COMPREHENSIVE GROUND WATER MONITORING EVALUATION

**VERNITRON PIEZOELECTRIC INCORPORATED
(MORGAN-MATROC INCORPORATED)**

OHIO ENVIRONMENTAL PROTECTION AGENCY

MARCH 31, 1995

Figure 5. Piezometric Surface Map (01/26/95)

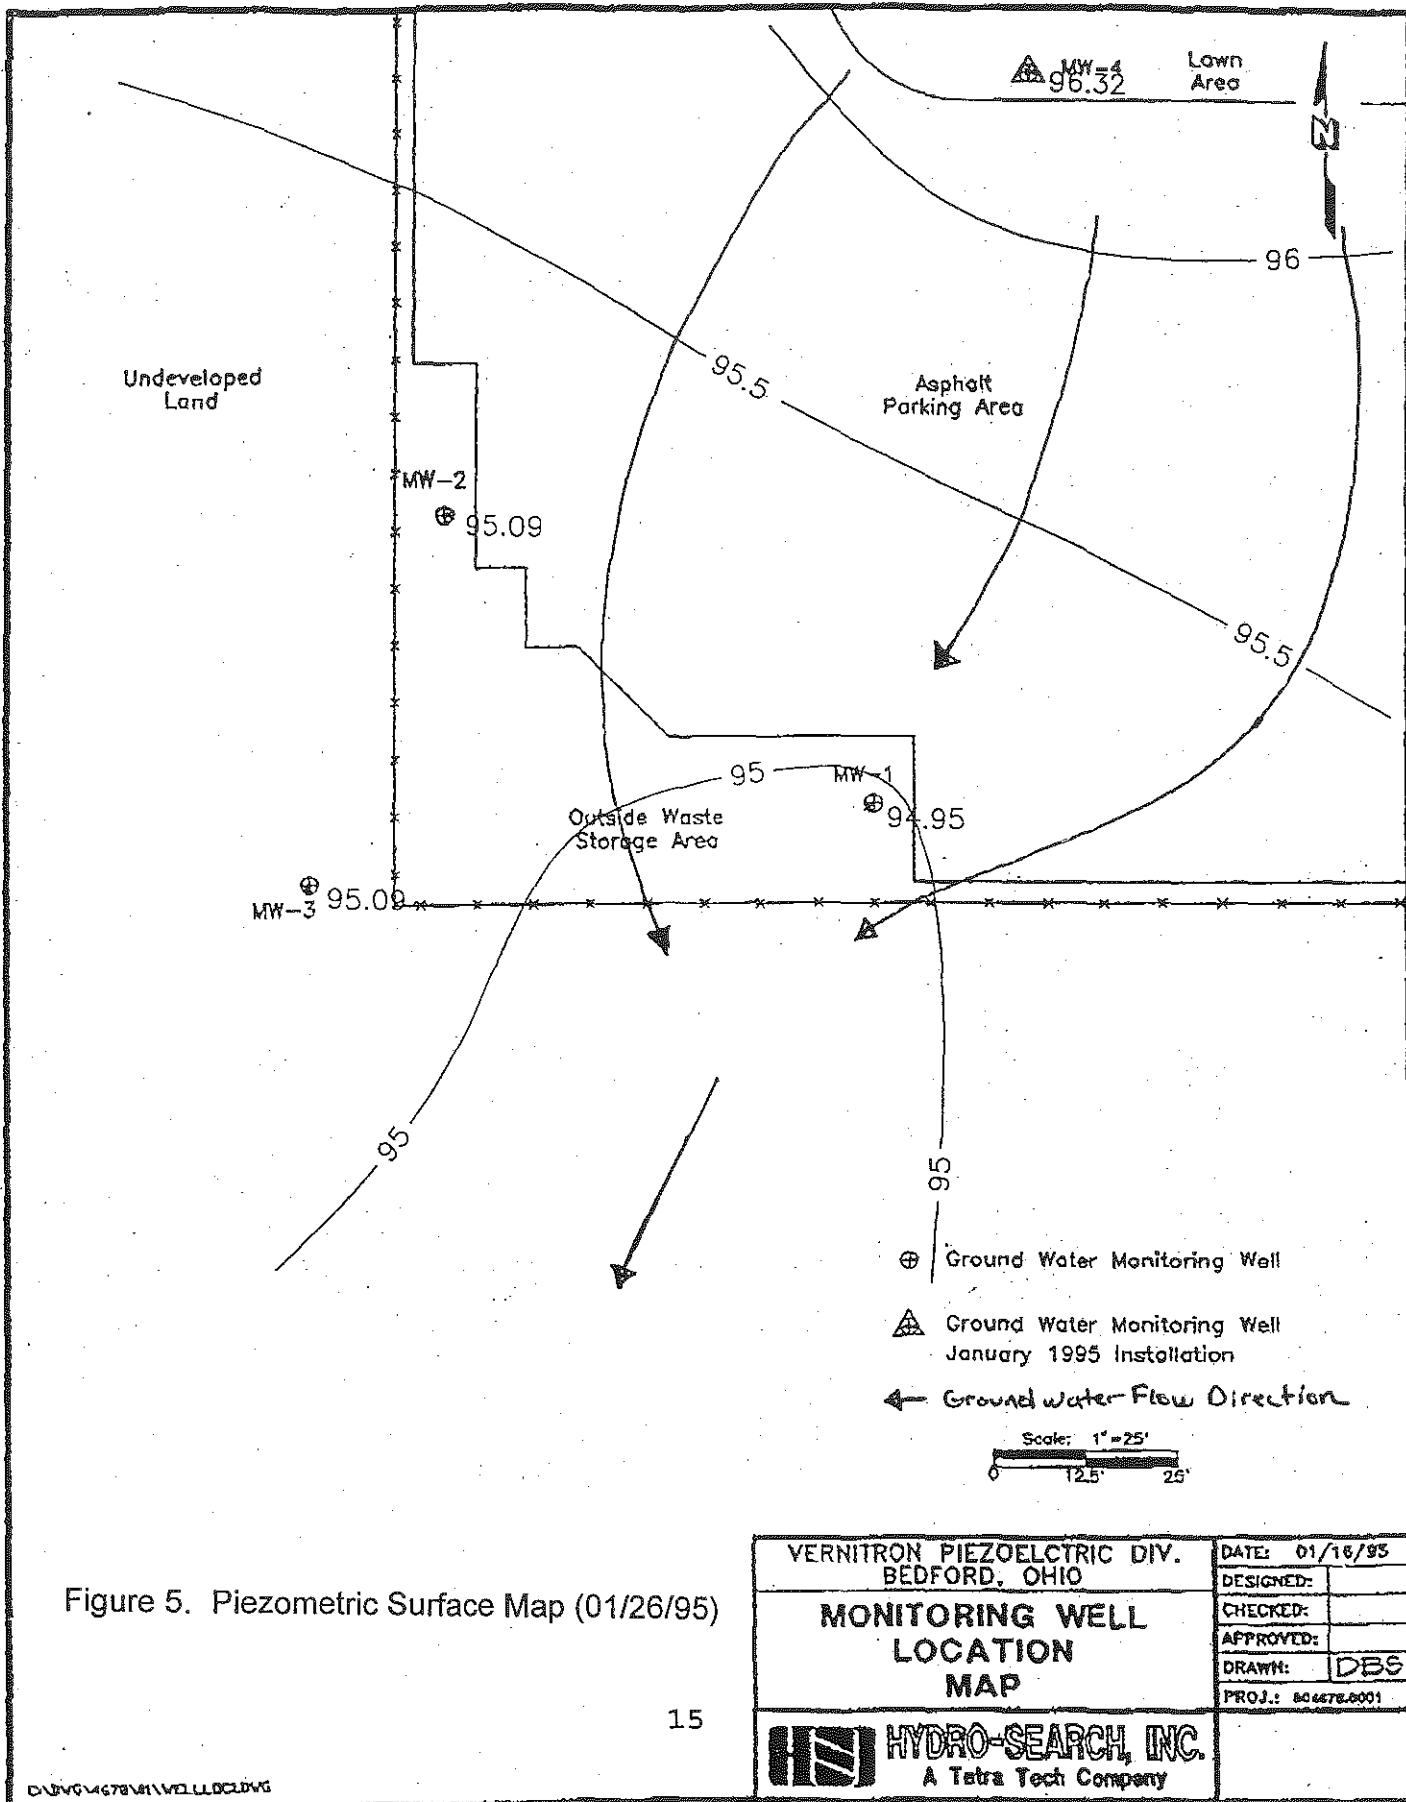
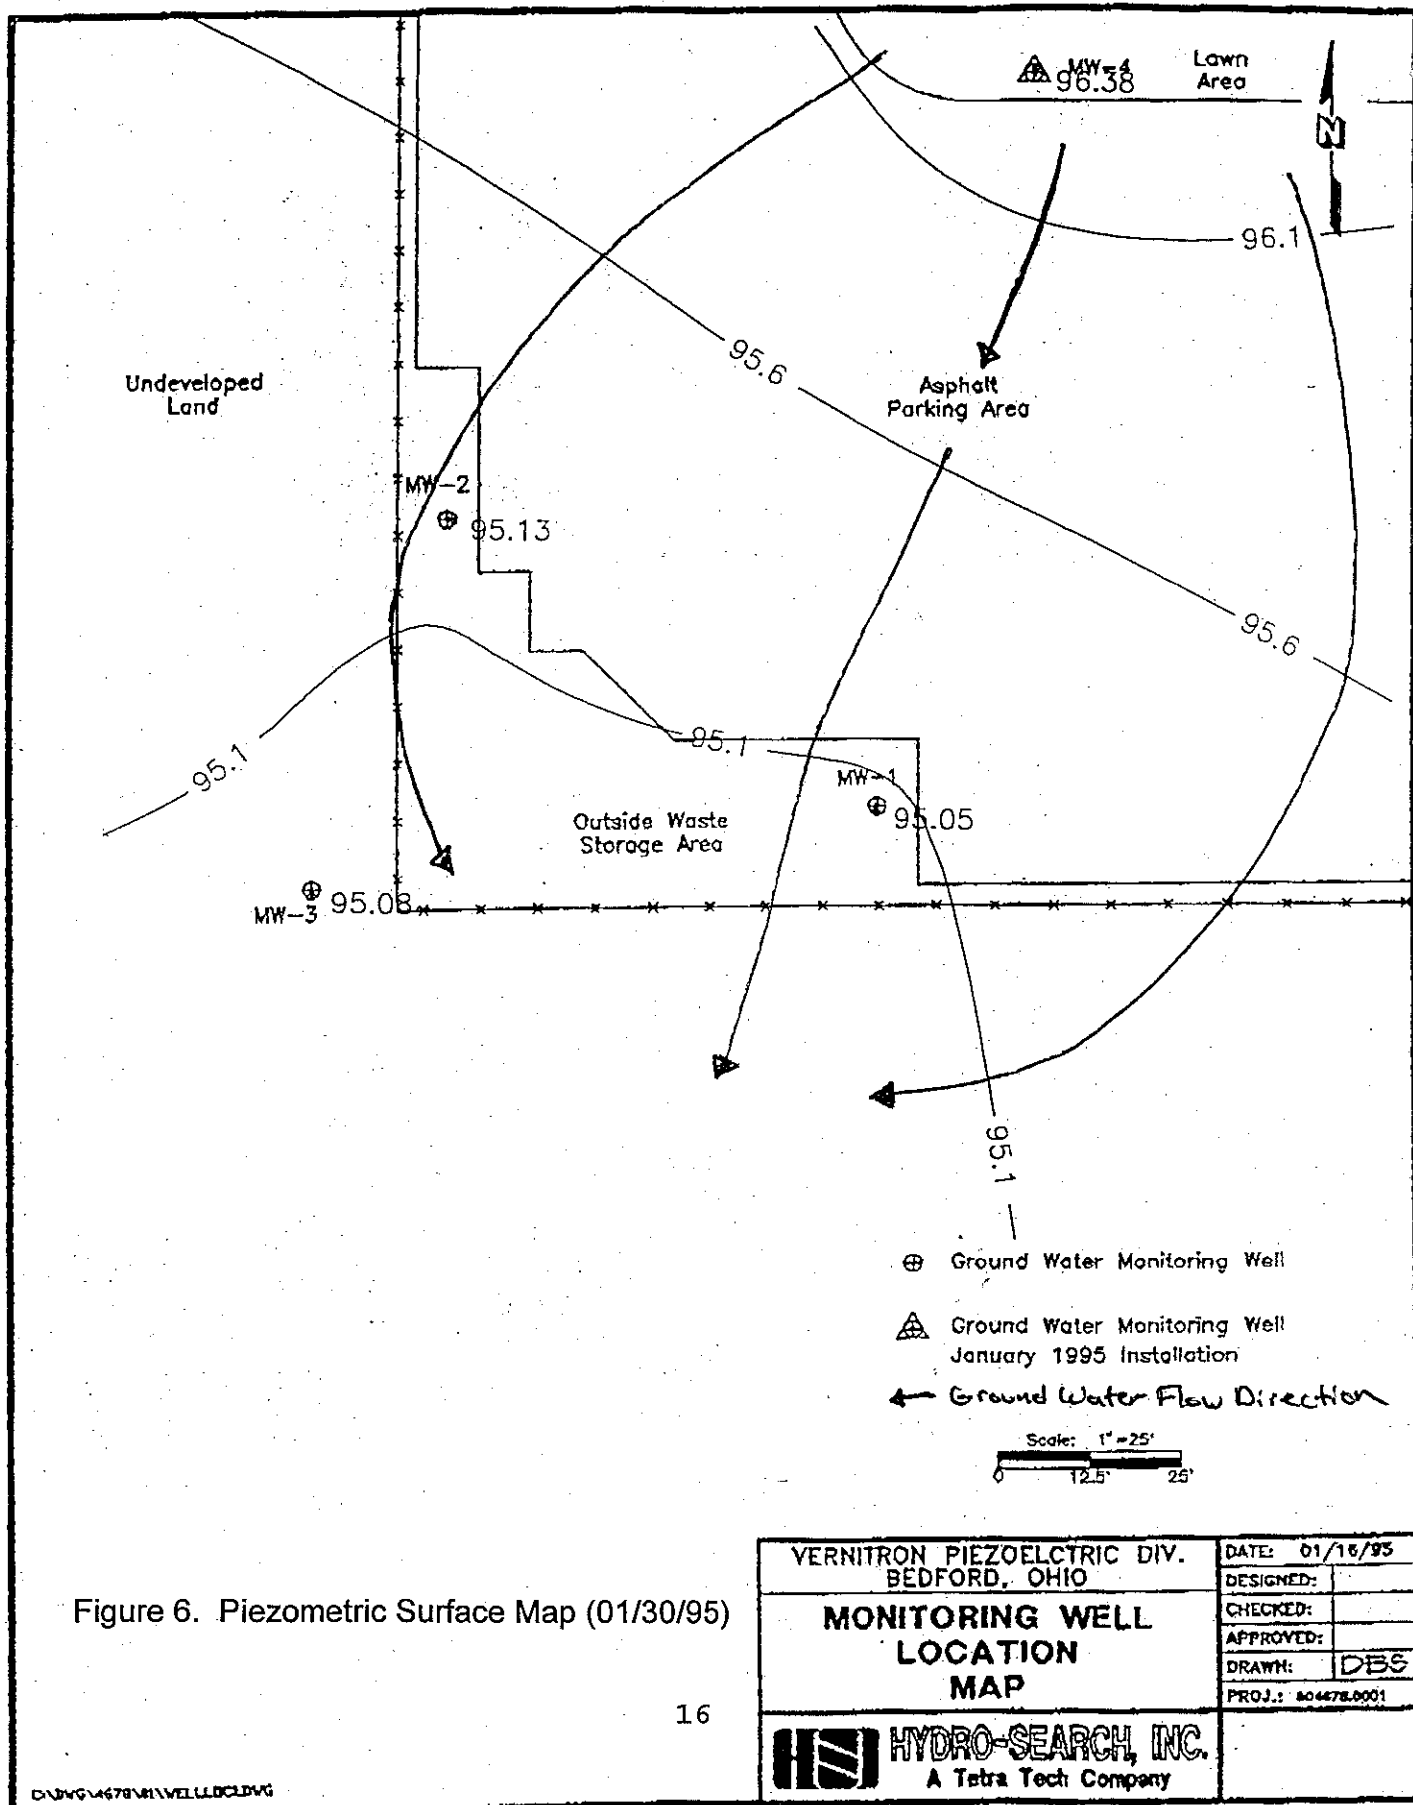
direction of ground water flow at the site. In addition the monitoring wells recently were changed from a flush mounted completion to an above ground completion. The January 1995 water level elevations are the first such data collected since the wells were modified. The change in ground water flow direction may also be the result of an error in the surveying of the reference measurement point. This should be investigated by the company. If the ground water flow direction calculated using the 1995 water level elevation data is correct, the company may not have in place a ground water monitoring system that meets the requirements of OAC 3745-65-91 (A)(2). However, additional investigation is needed to determine if this is a seasonal or temporal phenomenon, the result of a surveying error, or a permanent change in the hydraulic conditions at the site.

- 22a. The most recently collected water level elevation data may not be valid. The data indicate a shift in ground water flow direction. However, it is unclear at this time whether this apparent change in ground water flow direction is the result of seasonal or temporal variations in flow or to an error in surveying the recently installed well risers.
